Docket Nos. 50-280
and 50-281 ✓

Based on our review of your test results we have concluded that the Continental Instrumentation Cable in use at Surry Units 1 and 2 can perform the required function before, during and following specified abnormal environmental conditions. The details of our review are provided in the enclosed Safety Evaluation Report.

SAFETY EVALUATION BY THE OFFICE OF NUCLEAR REACTOR REGULATION
RELATED TO THE ENVIRONMENTAL QUALIFICATION OF SAFETY RELATED CABLE
USED BY THE VIRGINIA ELECTRIC AND POWER COMPANY AT
SURRY POWER STATION, UNIT NOS. 1 AND 2
DOCKET NOS. 50-280 AND 50-281

FIGURE D

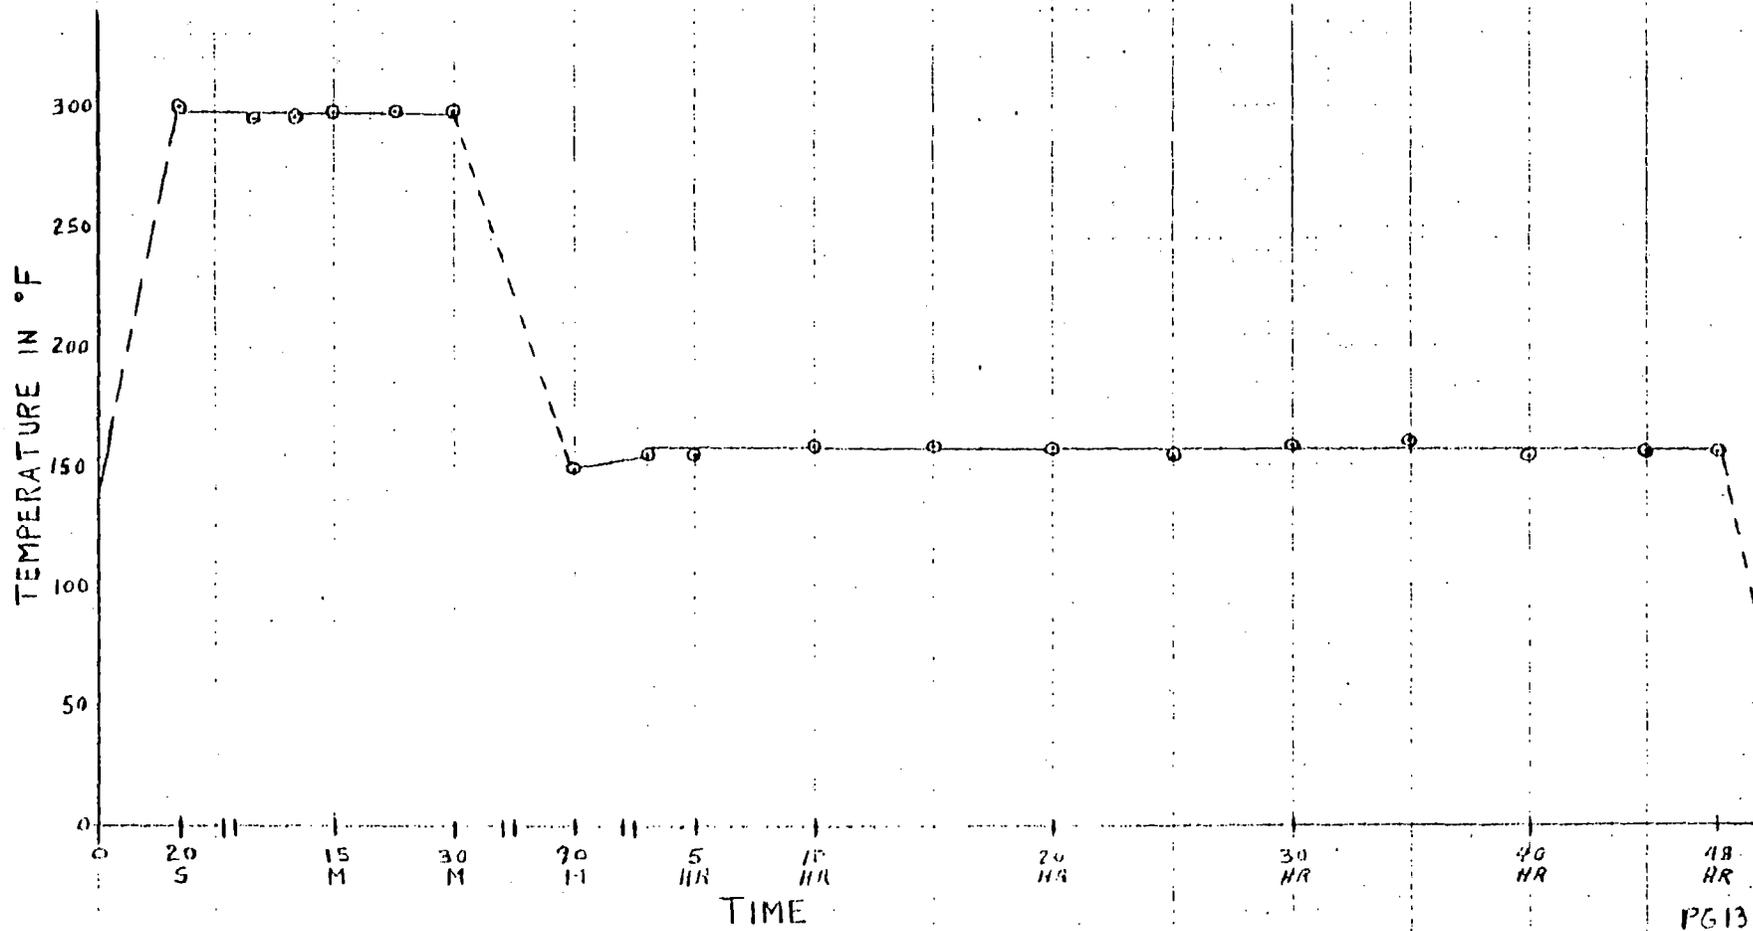
Three test samples, thermally aged for 60 hours at 100°C and irradiated to 20 megarads (MR), were installed in the test chamber, connected, instrumented and subjected to the LOCA environment (temperature/pressure/chemical spray environment). The test chamber LOCA temperature profile is shown in Figure D. Data were collected of the measurements of voltage and current throughout the 48 hours of the test.

By comparing the test data and the plant's temperature and pressure profiles for LOCA and MSLB events, we conclude that adequate margin per IEEE Std. 323-1974 is provided. (The temperature peak of 420°F during 20 to 90 second interval of the incident was not obtained during the test; however, the test temperature of 350°F was sustained for a period of 15 minutes to compensate for this. This deviation is provided for in the test procedure itself and is acceptable).
